24 February 2014

| Subject | 'As-Constructed' Rock Revetment | Job no. | [REDACTED] |

Background

| Title | NEW REDEMPTION WALL GENERAL ARRANGEMENT PLAN |

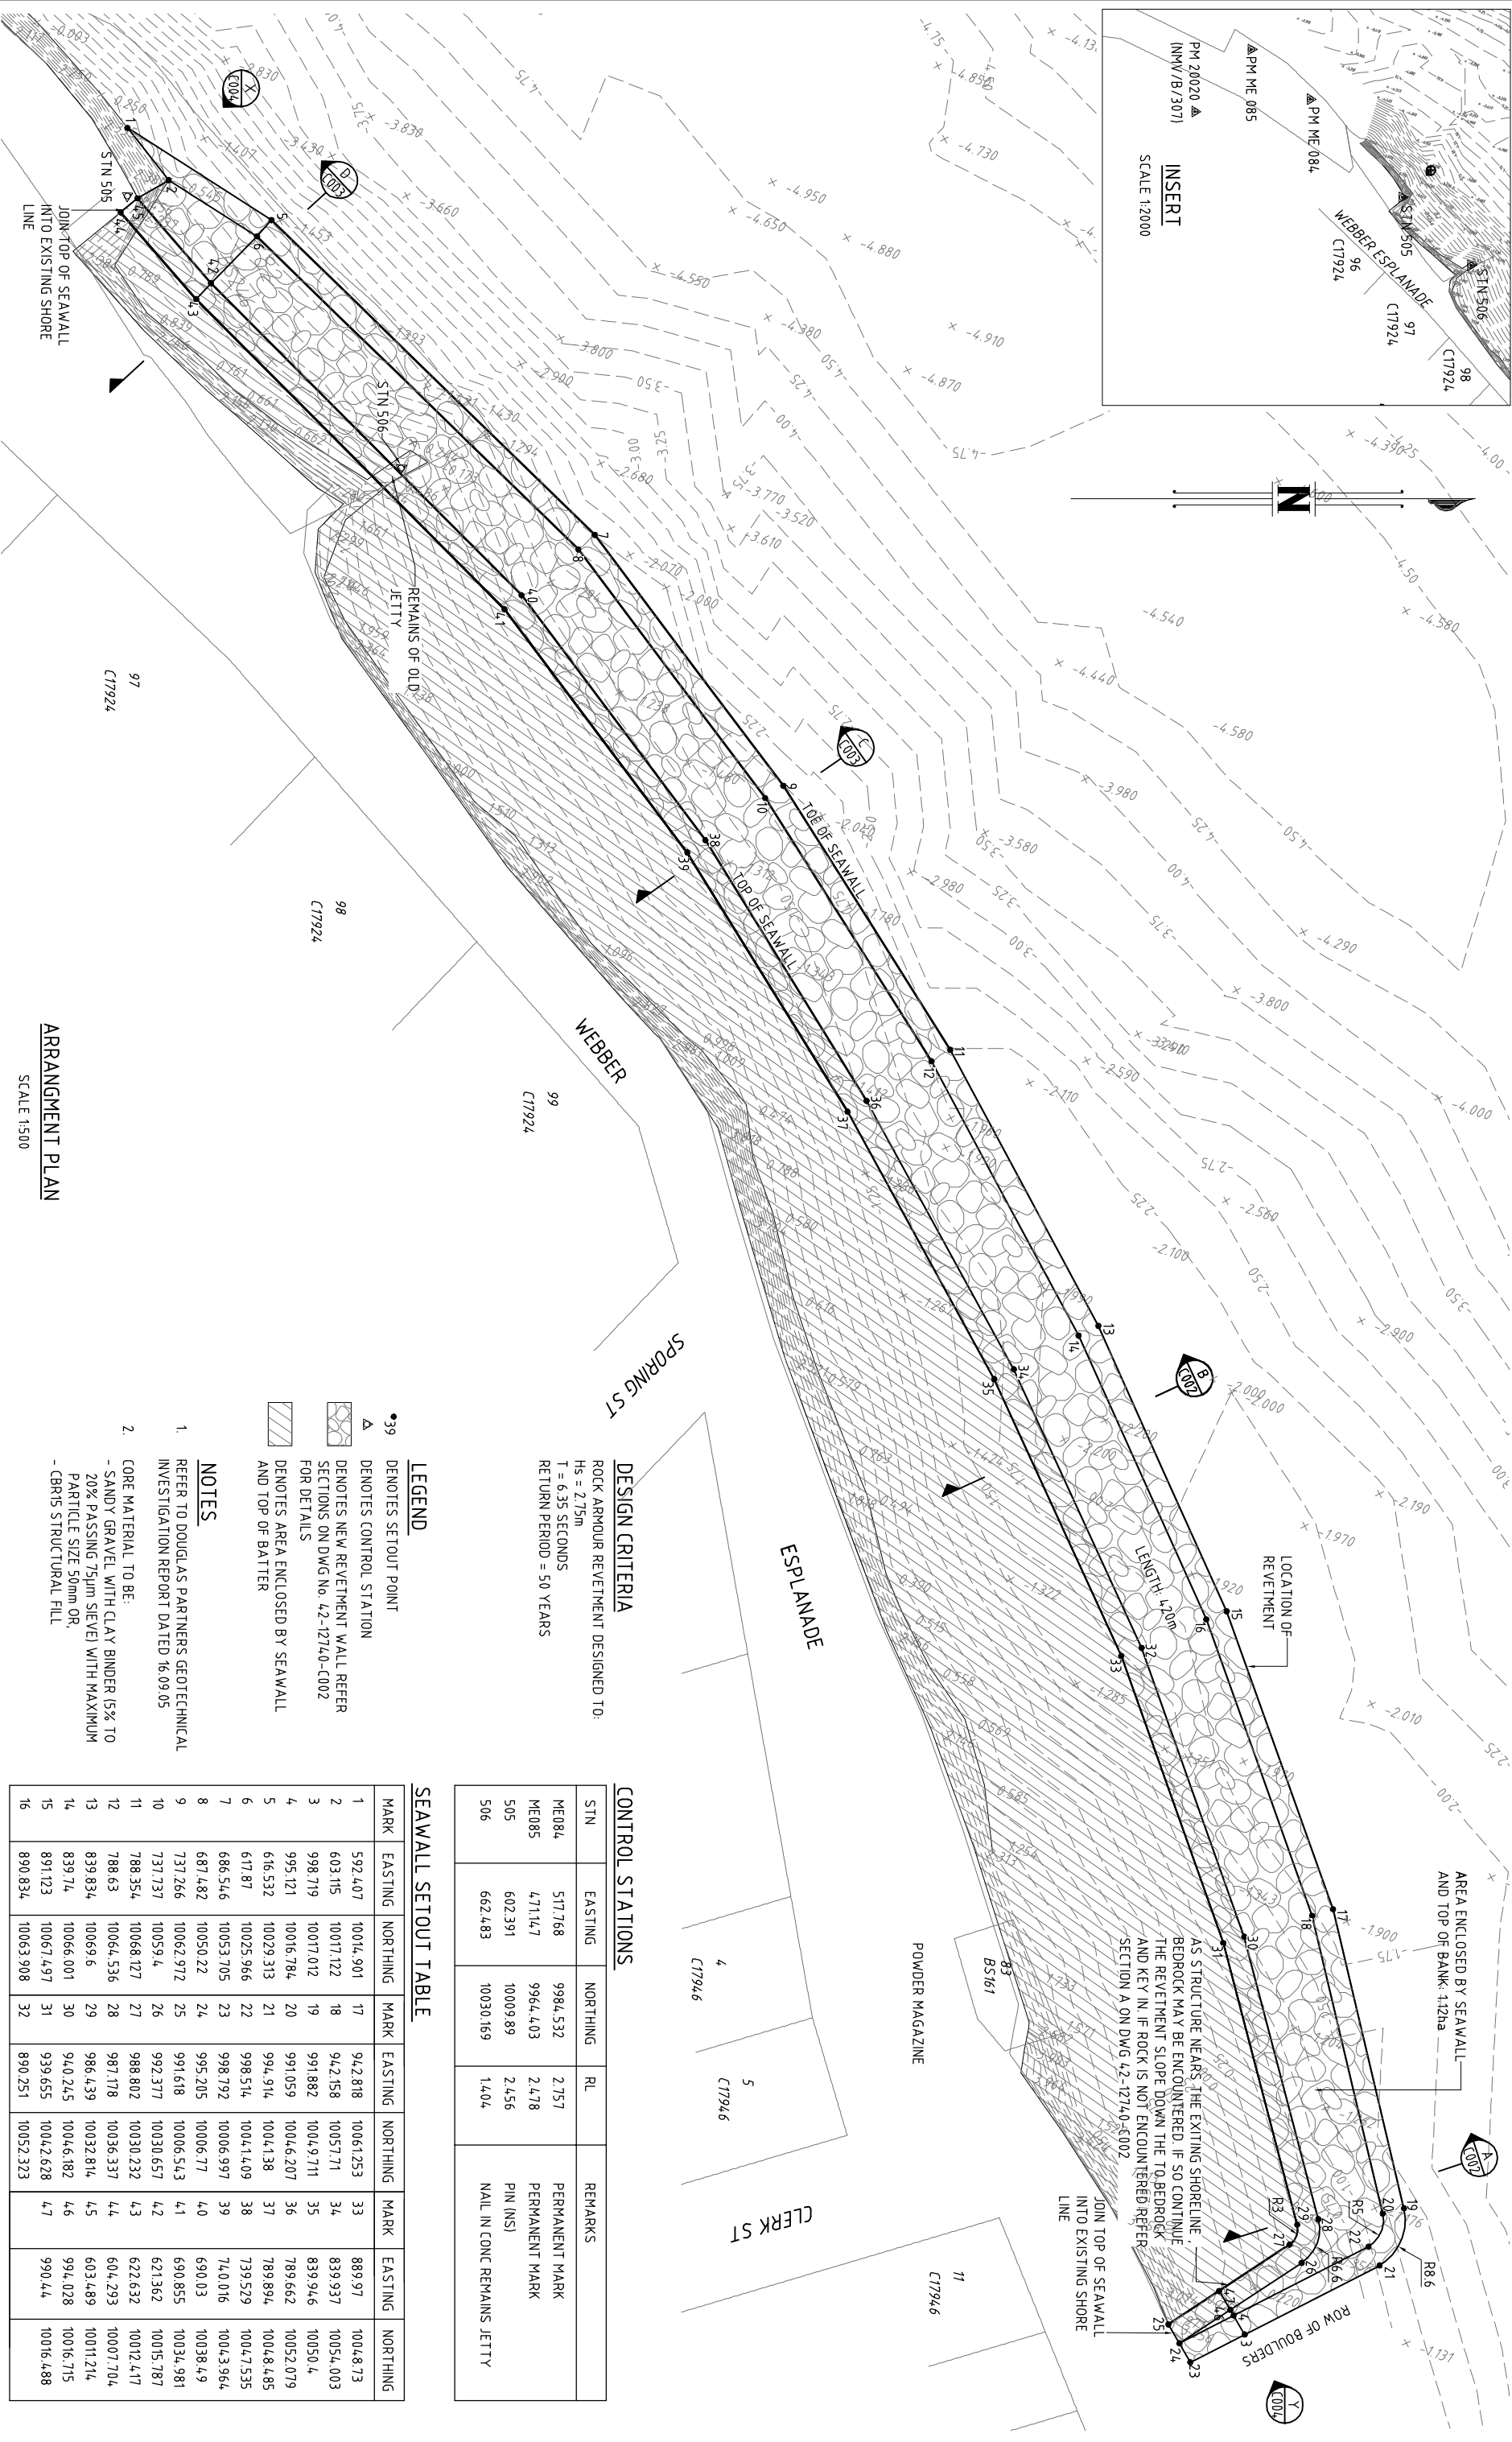
- a. SK-001 shows that the plan alignment of the 'as-constructed' revetment deviates slightly from the plan alignment shown on the design drawings.
- b. SK-001 shows that the rock revetment may not be complete.

GHD adopted the following design criteria for the revetment wall as shown on drawing 42-12740-C001;

Appendix B

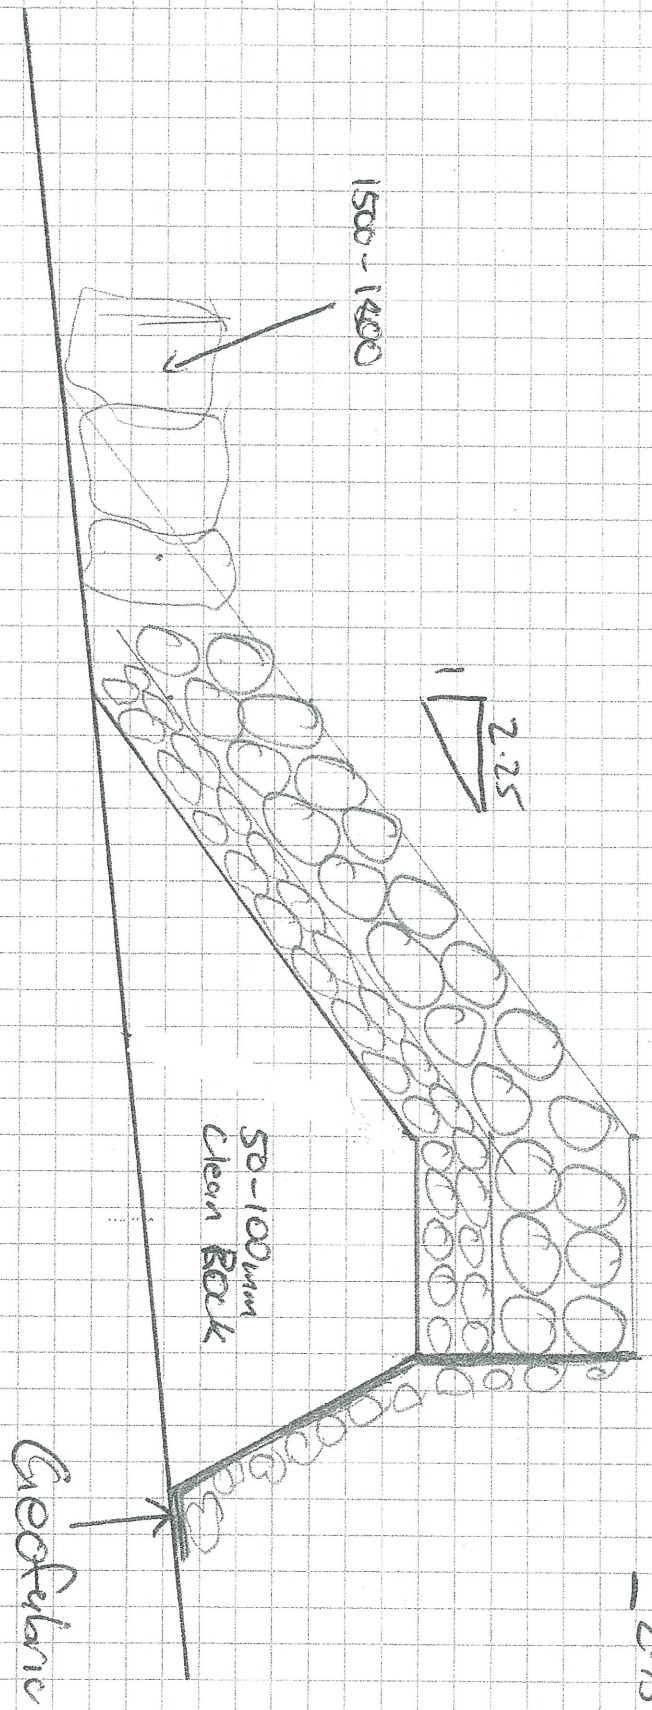
- c. The 'as-constructed' sketch provided in Appendix B is not consistent with the supplied 'as-constructed' survey (see SK-002 to SK-004). In particular;

- i. The two large rocks (1.5 to 1.8 m) cannot be confirmed.
 - ii. The crest of the 'as-constructed' rock revetment is substantially lower than the level of +4.237 m LAT provided in the Appendix B sketch.

- d. Geotextile layer was not placed beneath the filter layer, according to the sketch provided in Appendix B.
- e. It is our understanding that core material of '100-300 mm clean rock' was placed with the intent of negating the need for a geotextile layer beneath the filter rock as shown in photos 1 to 3 below. It has been confirmed by Cook Shire Council that the core material was placed within the entire length of the structure.

COOK SHIRE COUNCIL
WEBBER ESPLANADE - COOKTOWN
REVTMENT WALL - AS BUILT
DESIGN CHECK - SECTIONS SH1

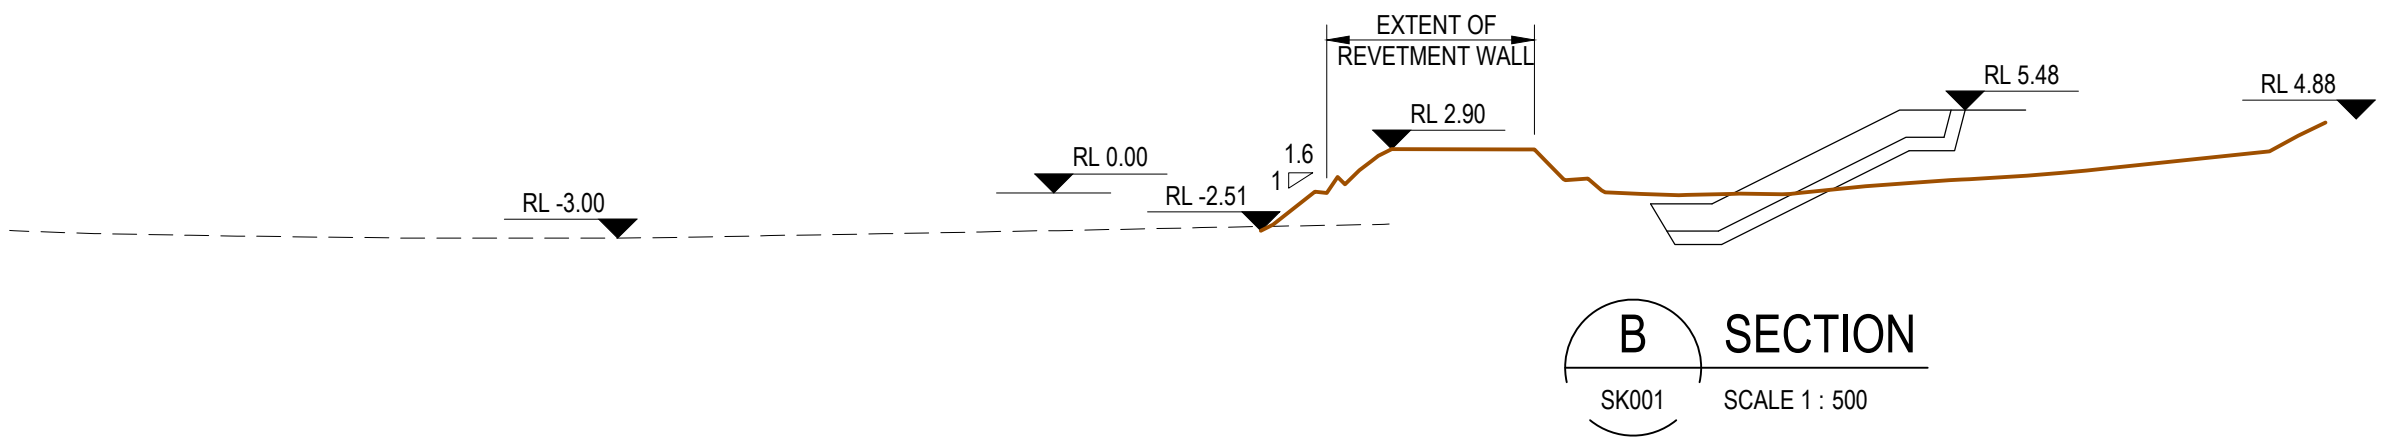
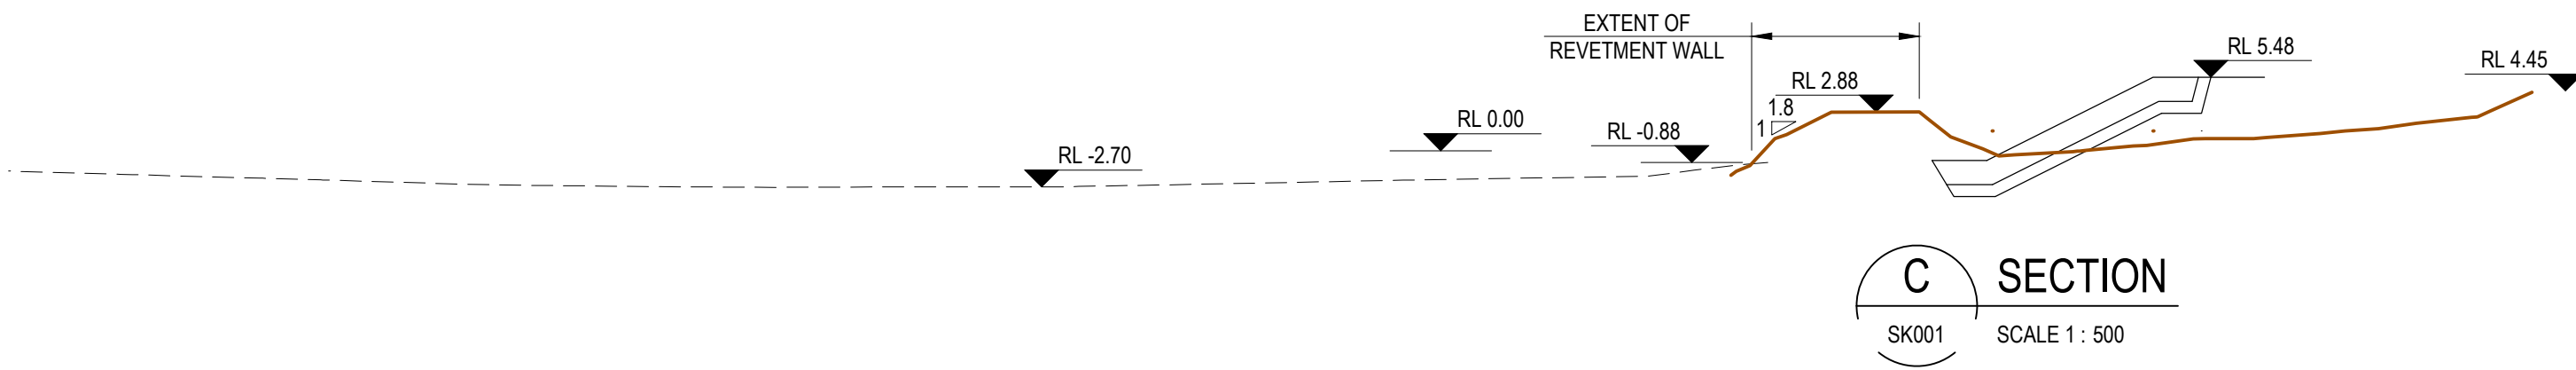
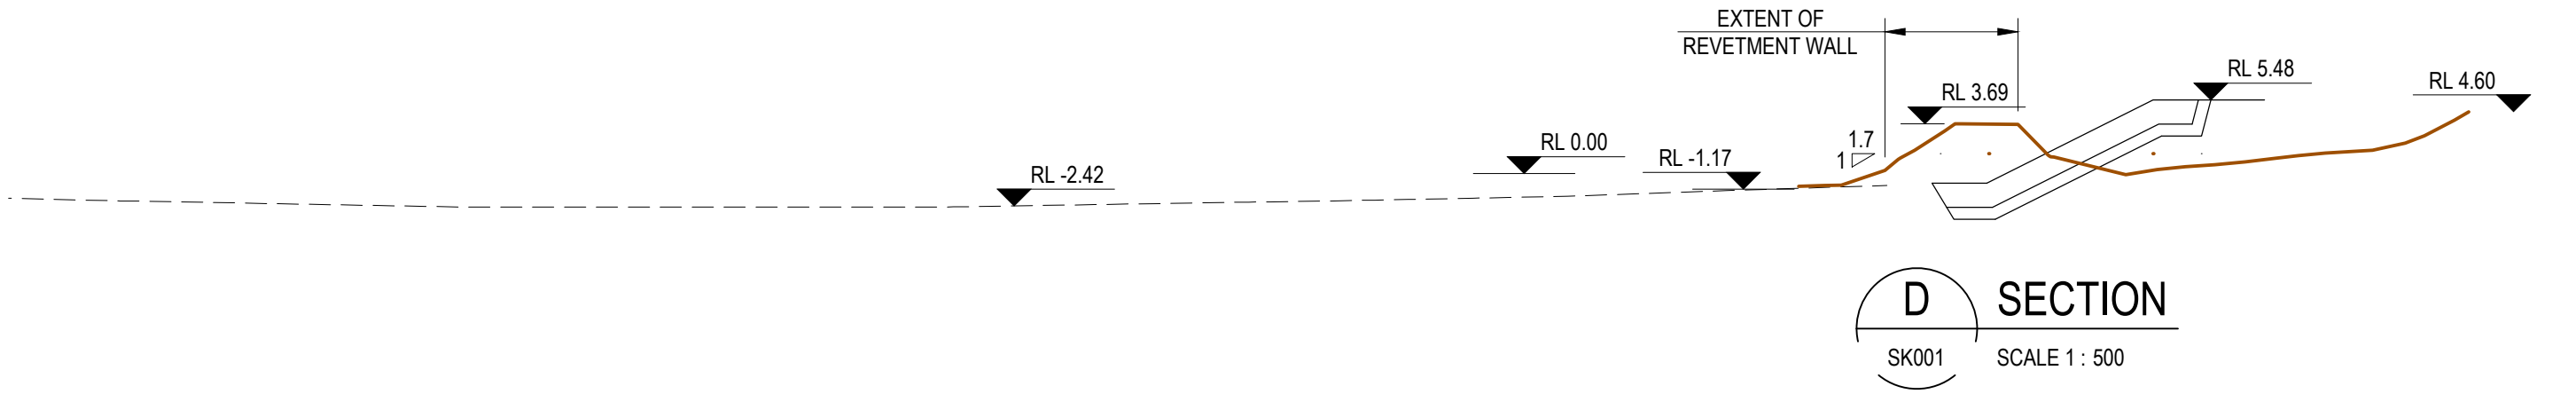
The sections taken from the 'as-constructed' survey, as shown in SK-002 to SK-004 within appendix C, shows that the rock armour slope varies from 1 in 1.1 at the western end trending up to 1 in 2 at the eastern end. If the survey is a true reflection of the 'as-constructed' rock armour slope, it is recommended that additional rock is placed on the armour face in order to obtain the 1 in 2 design slope.

In order to meet this overtopping criterion, the rock revetment crest level would need to be uniformly raised along the structure to +3.5 m AHD or +4.98 m LAT. The 'as-constructed' survey shows that currently the crest level varies from +1.78 m LAT to approximately +4.0 m LAT. Overtopping discharge per metre length of wall during the design event is expected to exceed 300 litres per second for the current 'as-constructed' crest.

- Photos taken during construction and QA site records, if available, should be provided in order to confirm the assumptions made during the assessment.
- It is recommended that the seaward face of the revetment be topped up with rock armour to achieve a 1 in 2 slope uniformly along the full length of the revetment.
- Raising the crest finish level with rock armour to +4.98 m LAT is recommended in order to ensure overtopping volumes are within the guidance values provided by CIRIA.
- In the process of raising the crest, the existing small graded rock as shown in photo 4 and 5 should be removed and replaced with rock armour.
- Install the 1200R Elcomax geotextile as per the recommendations provided above.
